CITY OF ALBUQUERQUE

February 17, 2017

RE: Arroyo Vista Apartments
Grading and Drainage Plan
Engineer's Stamp Date 2-6-2017 (File: G16D153)

GRADING AND DRAINAGE PLAN

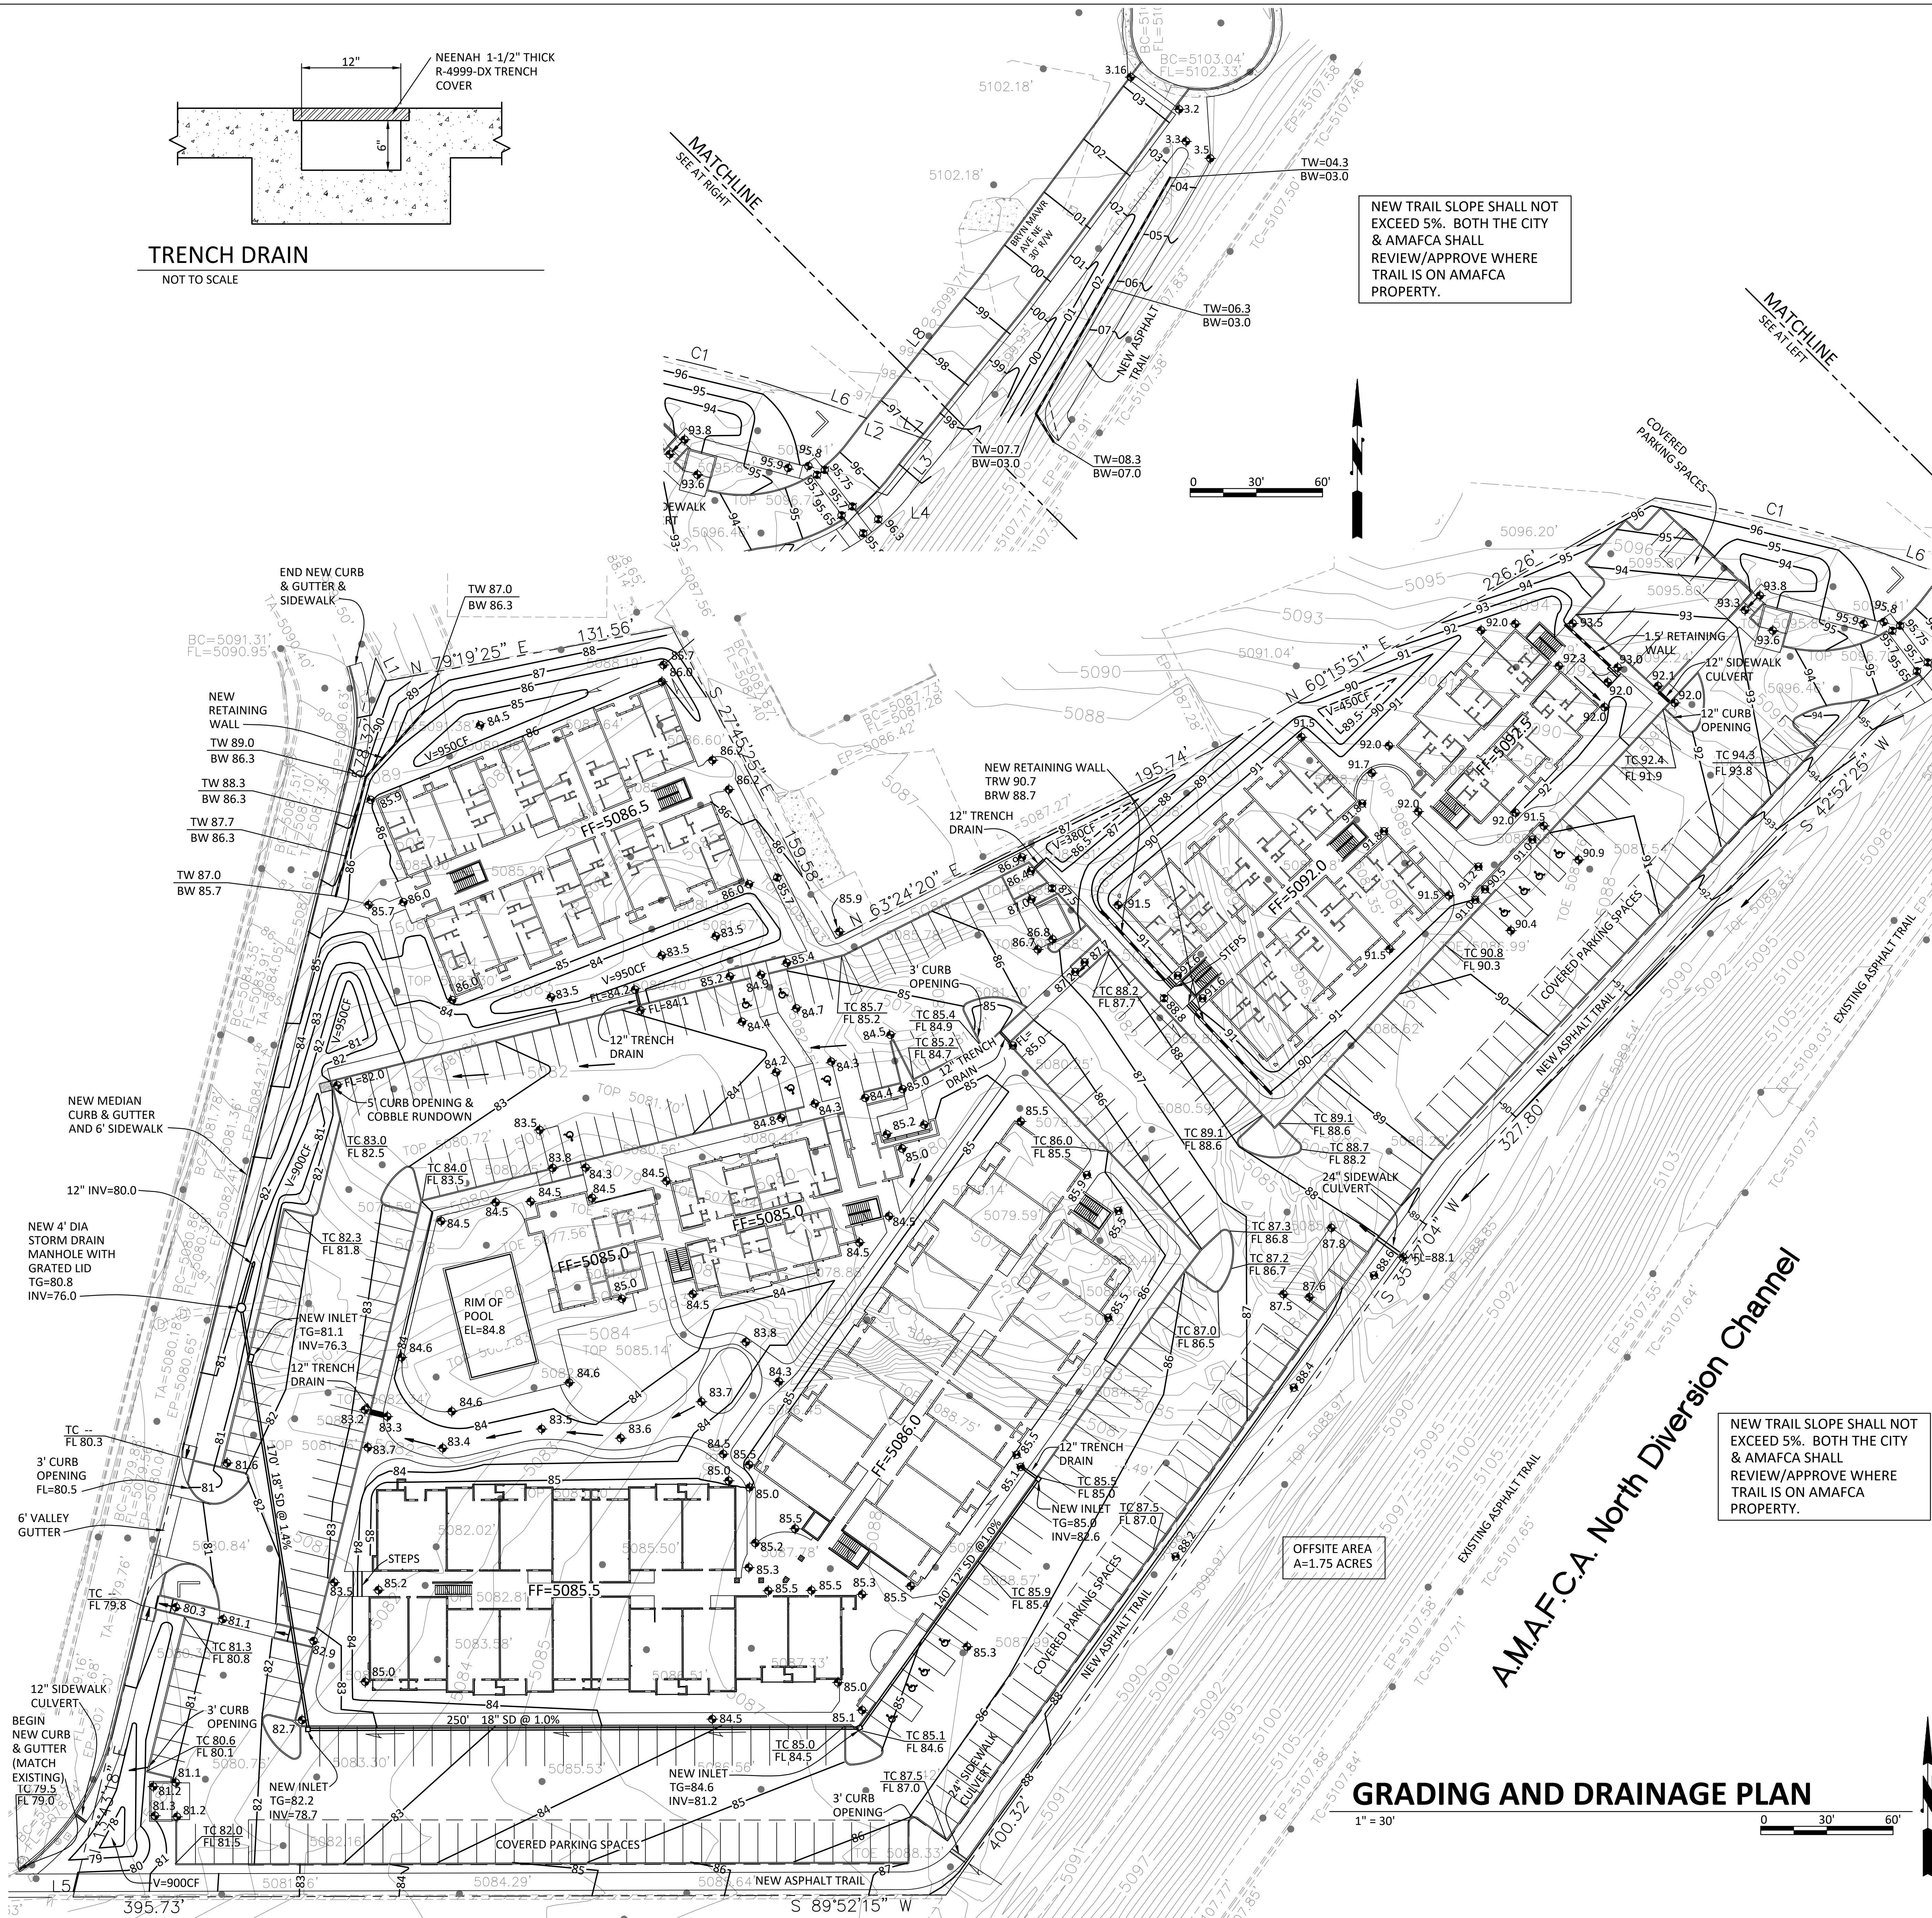
1. AMAFCA approval is required.
2. Hydraulic calculations for the onsite storm drain is required.
3. Stand the pipe or elevate grate for storm drain on the west side of the site. How is the first flush pond volume being accomplished?

4. Provide first flush volume calculations for individual ponds.
5. It's seems there is an offsite flow from the northeast side of the site. Provide a narrative for this offsite flow, is this part of the 1.75 AC offsite area? Was the impervious area assumed in calculation?

6. Who will maintain the retaining wall on the northeast side outside project? Do you have construction easement?
7. Provide document on the city project 595281 which allows 50.6 cfs discharge.

8. Provide onsite sub basin and show how much runoff is being routed to the sidewalk culvert at the southwest corner of the project. Include side walk culvert capacity calculations.

9. Are you allowed to drain to access road to the west? Is there adequate capacity via surface? and downstream storm drainage system? Do you have access and drainage easement across adjacent property?

10. Show the property line more clearly. Show full extend of the project on this plan.
11. Erosion and sediment control plan must be approved prior to building permit approval.
